A Rapid Assessment of Sediment Delivery from Clearcut Timber Harvest Activities in the Battle Creek Watershed, Shasta and Tehama Counties, California

Appendix A

October 3, 2011 CVRWQCB review of turbidity data

SUBJECT: RESPONSE TO THE CALIFORNIA SPORTFISHING PROTECTION ALLIANCE'S ANALYSIS OF STREAM SAMPLING DATA IN THE BATTLE CREEK WATERSHED.

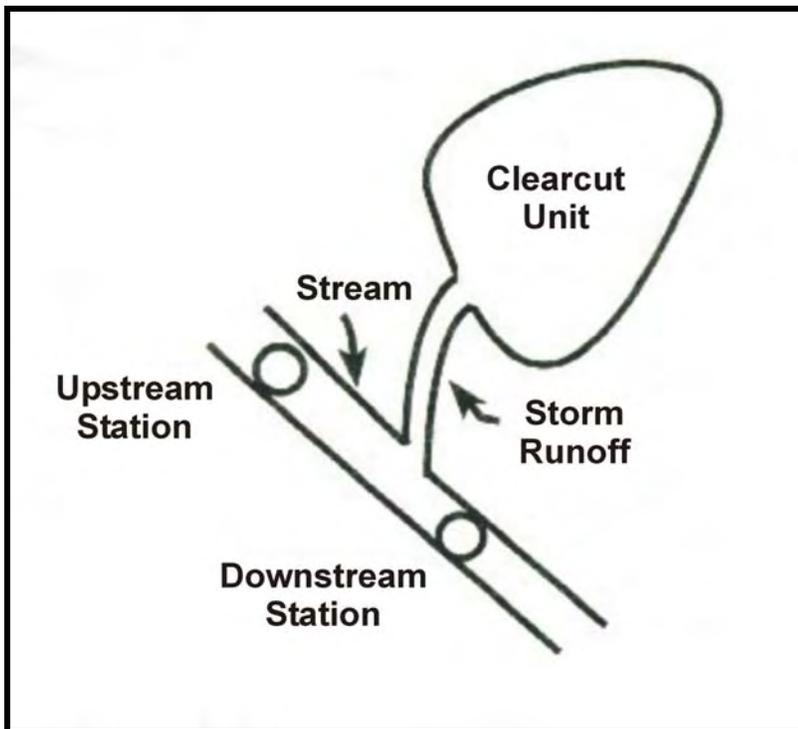
In contrast, above-and-below comparisons of Four Creeks data are done between monitoring stations a minimum of 1.2 miles apart, with a maximum distance of 6.7 miles between stations (Table 1; Map 1 and 2). To control variability, above-and-below stations should be hundreds of feet apart, not miles apart for comparison purposes (MacDonald et al., 1991; MacDonald, 1992). Also, the difference in watershed area between compared stations ranges from 0.9 to 104.3 mi² (Table 1), with some monitoring stations having two orders of magnitude difference in watershed area (i.e., FMC to DCH; see Map 2b). Large longitudinal distances and large differences in watershed areas between above-and-below sampling points introduces too much uncontrolled variability, in addition to an increasing number of potentially confounding land uses, to discern significant changes in turbidity due to timber harvest. Potential turbidity increases from clearcutting are only one of many different natural and anthropogenic sediment sources (e.g., bank erosion; channel incision; grazing; county roads) in the watershed. Spatial variability in controlling processes between sites (e.g., sediment transport capacity; sediment supply) can easily account for the differences in turbidity between monitoring stations (Gomi et al., 2005; Markman, 1990).

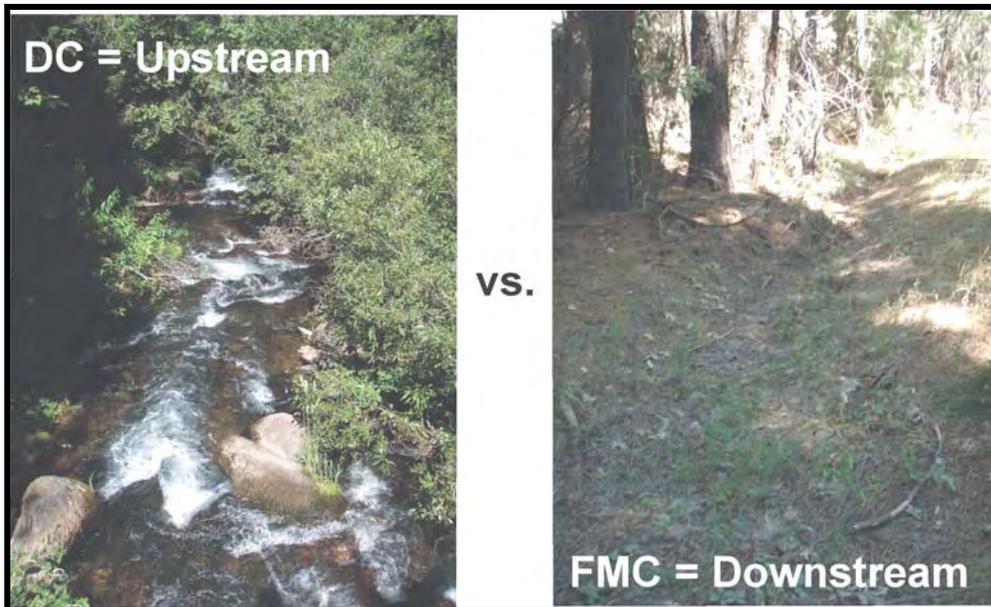
Furthermore, the comparison between the FMC and DC sites, FMC and DCH sites, and CCC and CC2 sites are inappropriate in that they are each comparisons between two entirely different streams, rather than above-and-below comparisons of the same stream (Figure 2; Map 2a and Map 2b;). Turbidity comparisons are also made between the Four Creeks

Figure 3. Mean daily flow ($\text{ft}^3 \text{s}^{-1}$) and turbidity (NTUs) at the Lower Battle Creek rotary screw trap from October 1, 2002 through September 30, 2003 (taken from Whitton et al., 2007).

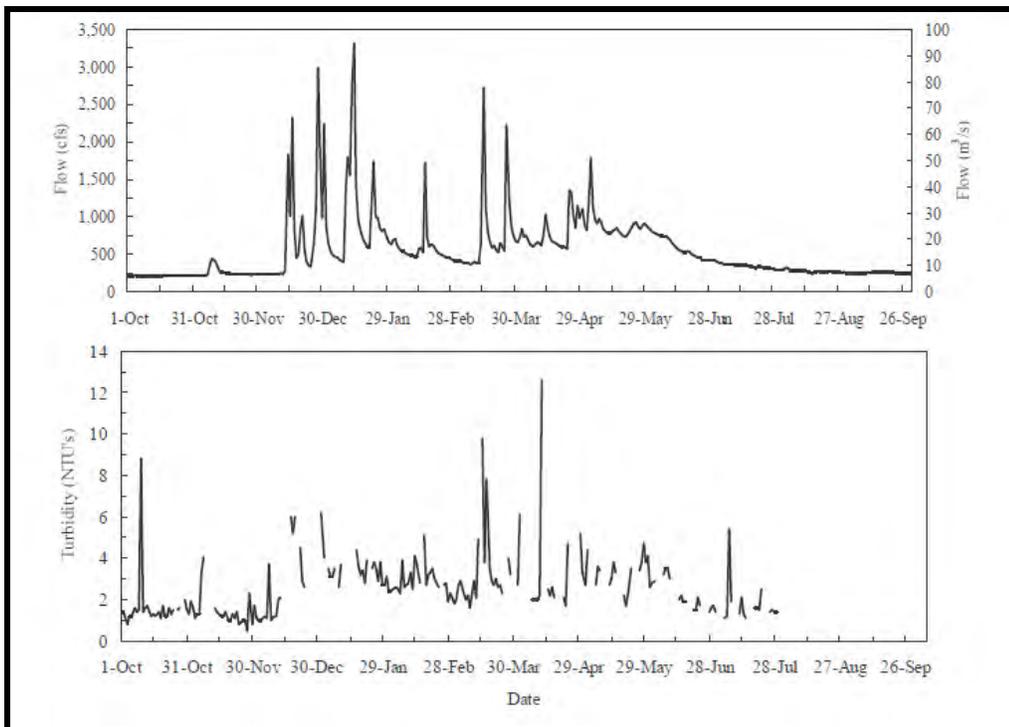
The CSPA analyses details Basin Plan violations by comparing 1999-2001 Coleman Fish Hatchery turbidity data to the turbidity data in the Four Creeks area collected from 2009-2011. Central Valley Water Board staff attempted to find the 1999-2001 data collected by the United States Fish and Wildlife Service at the Coleman Fish Hatchery on Battle Creek (see linked document in CSPA letter¹). While staff did not find data conforming to this time span, staff did find graphed turbidity data for the Coleman Fish Hatchery from October of 2002 through September of 2003 (see Figure 3). These data indicate a maximum turbidity value of approximately 13 NTU, with the majority of data falling within a range of 1 to 6 NTU – generally imperceptible by the naked eye. In the absence of the 1999-2001 tabular data, we can not compare the distributions of turbidity data from the Coleman Fish Hatchery with the Battle Creek Alliance data (i.e., Four Creeks data). However, we can make general statements regarding the appropriateness of watershed-scale data comparisons from samples taken during different years.

Turbidity is often used as a surrogate for suspended sediment concentration (Lewis, 1996). Hence, much of our knowledge regarding the temporal variability of suspended sediment also applies to turbidity. Not only can turbidity vary highly during a storm event, but also between events and years due to temporal fluctuations in transport capacity (i.e., variations in flow

Figure 4. Turbidity values by monitoring station for the Four Creeks dataset (n=549). The solid horizontal line represents the 25 NTU threshold for stressing salmonids (Sigler et al., 1984). The dashed line represents the turbidity threshold visible by the human eye.

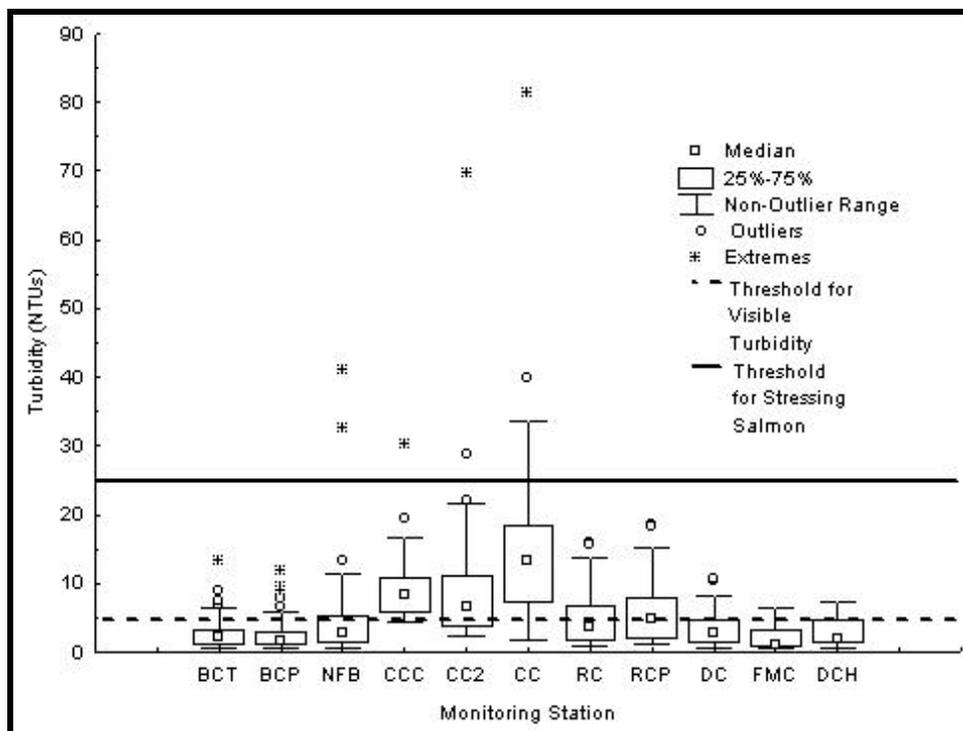
CSPA contends that the turbidity exceedances pose a threat to the ongoing salmonid restoration project in the watershed. As such, it is important to compare the Four Creeks dataset with known turbidity exposure-response relationships for salmonids.

A frequently used exposure-response relationship is the one documented by Sigler et al. (1984). This is also frequently cited as one of the lowest thresholds for salmonid response. Their laboratory study showed that as little as 25 NTUs of turbidity over a 14-day duration caused a reduction in steelhead and coho salmon growth. Figure 4 shows how the Four Creeks data relates to this turbidity threshold, and cumulative frequency analysis indicates that 97.6% of the 549 samples fall below the 25 NTU threshold. In fact, 60% percent of the data was below 5 NTU – the level of turbidity imperceptible by the human eye.

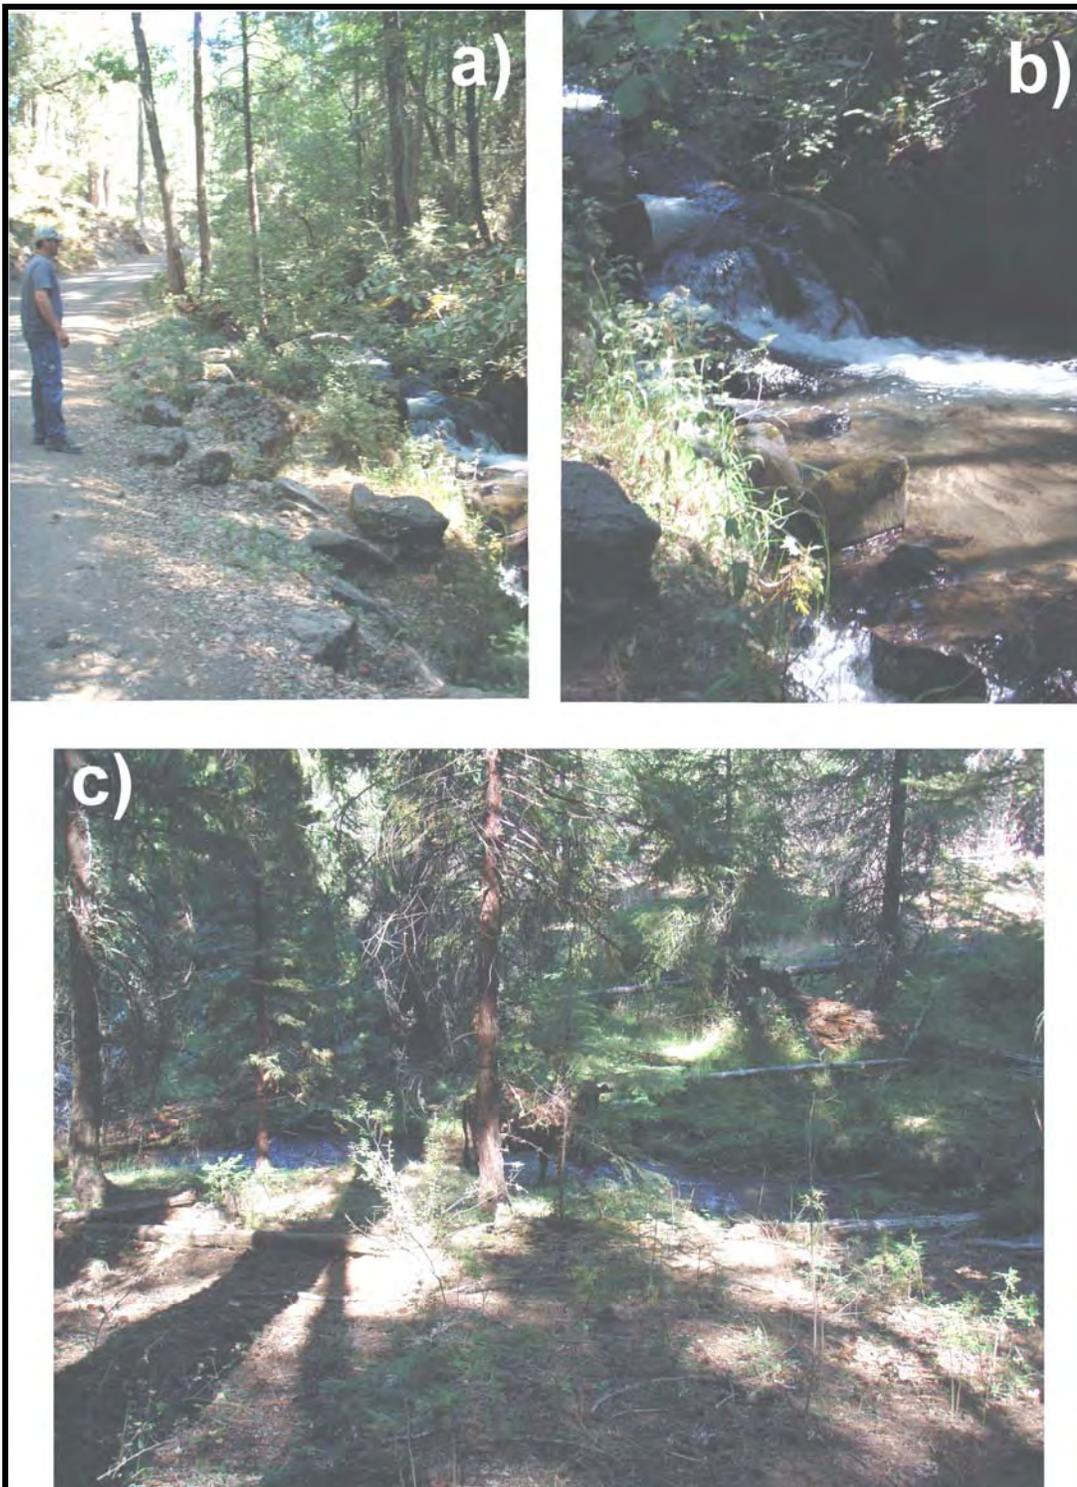
The Four Creeks dataset does provide some spatially explicit information into potential water quality problems in the watershed. For example, the Four Creeks dataset indicates that the Canyon Creek monitoring stations (i.e., CC, CC2, and CCC) have elevated turbidity levels relative to the other monitoring stations. Field inspection of the Canyon Creek watershed indicates significant sediment delivery from the county maintained Rock Creek Road, which parallels Canyon Creek for much of its length (Figure 6a and b). All the Canyon Creek monitoring stations showed direct evidence of fine-grained sediment delivery from the Rock Creek Road, which likely accounts for the elevated turbidity at all three stations. A private in-holding within the Canyon Creek watershed also allows grazing, with evidence of livestock grazing in the channels (Figure 6c). No sediment plumes or erosion features were observed coming directly off the nearby clearcuts. These observations indicate that sediment sources other than clearcuts might be resulting in the elevated turbidity at the Canyon Creek monitoring stations.

Map 1

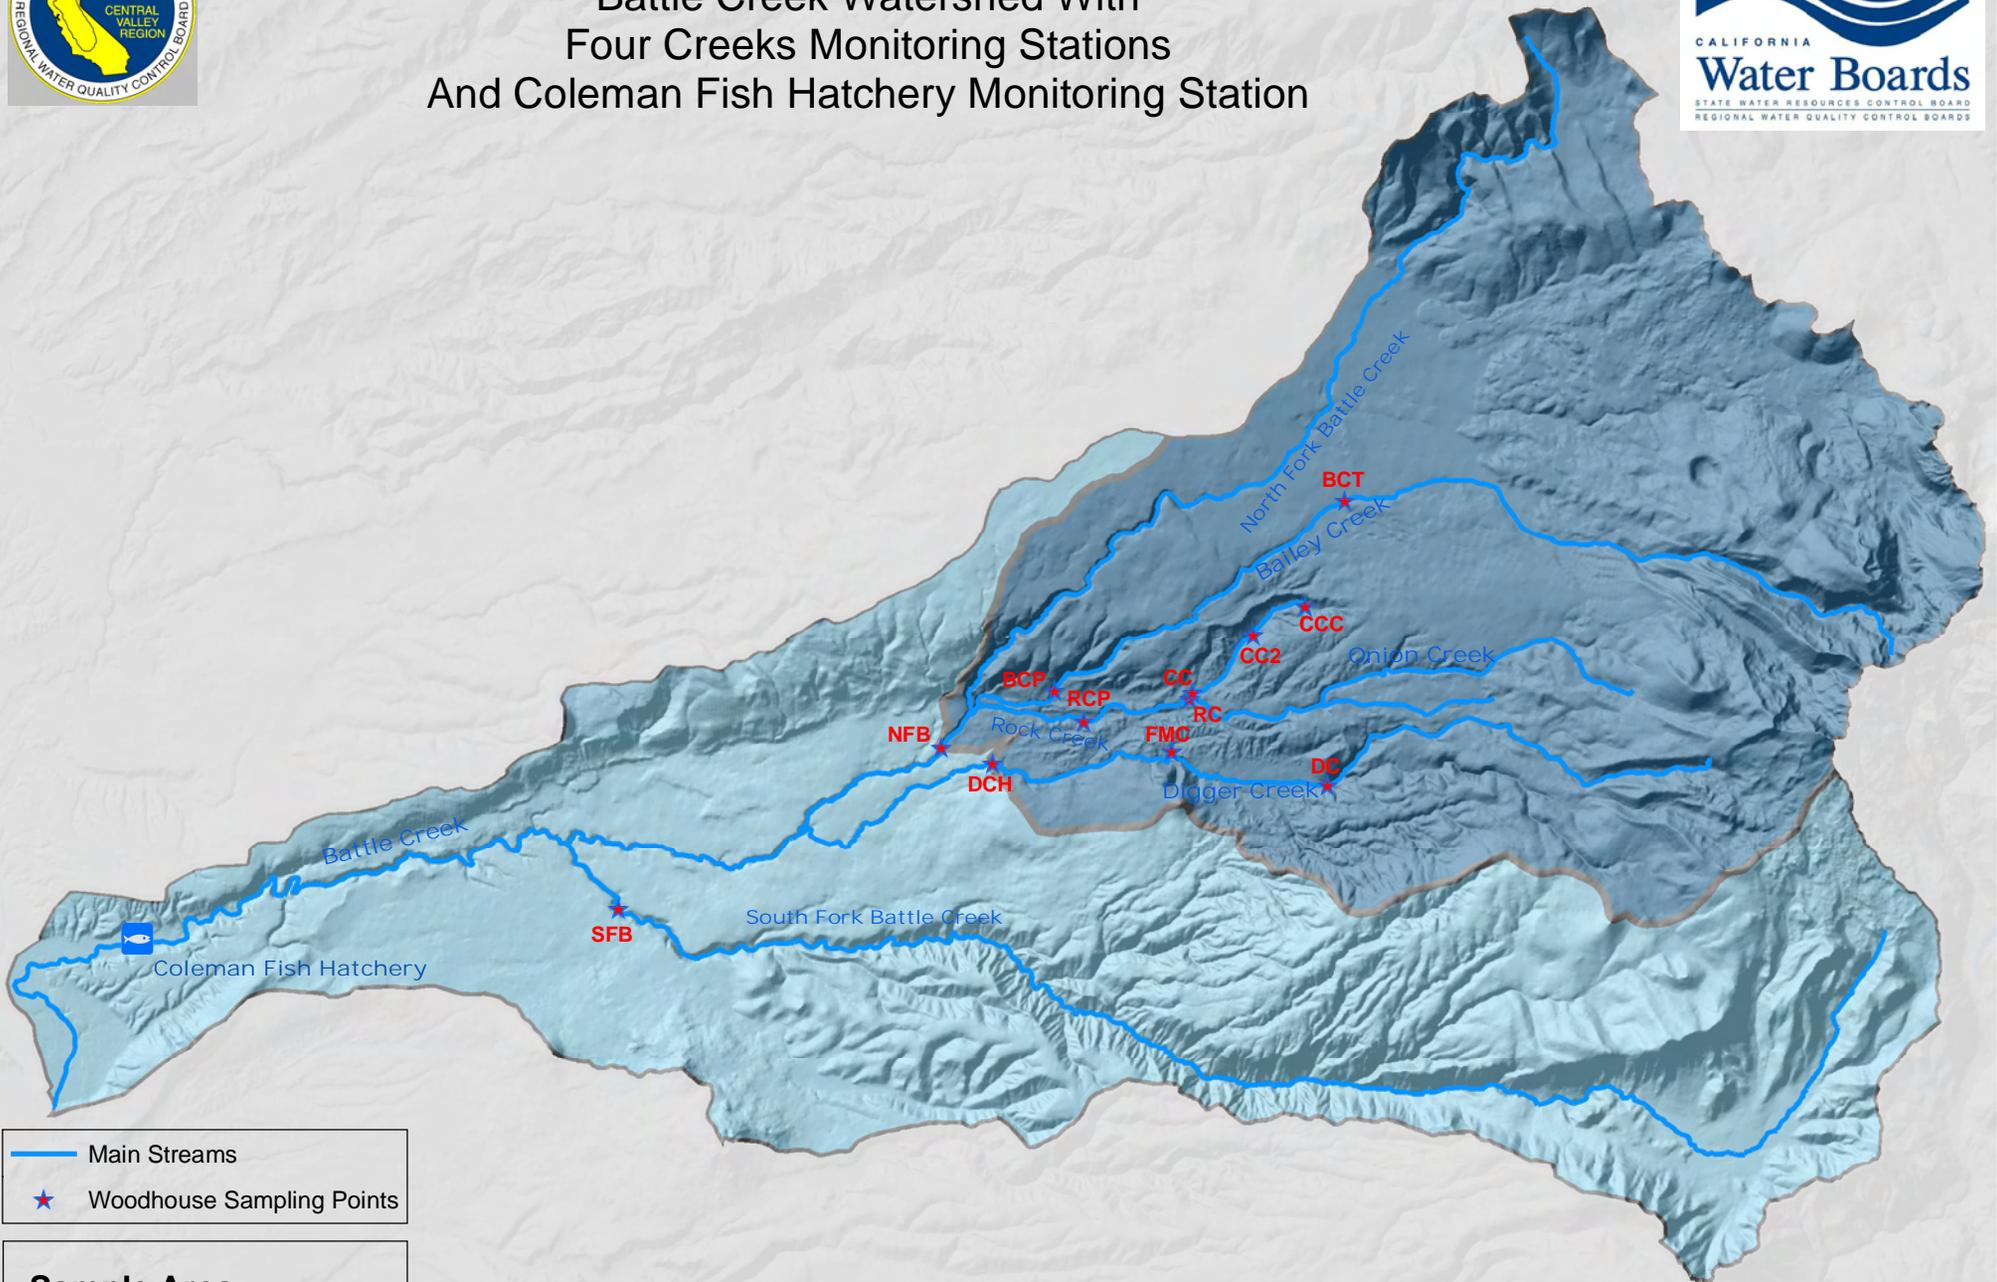
dataset and turbidity grab samples made at the Coleman Fish Hatchery, despite the fact that the Coleman Fish Hatchery is 19.3 miles downstream (Map 1), and has a watershed area 300% (i.e., 350 mi² versus 136.8 mi²) larger than the Four Creeks area. Again, there is no consideration for the spatial variability in the controlling processes that influence turbidity, and how these might affect the turbidity differences between monitoring stations.
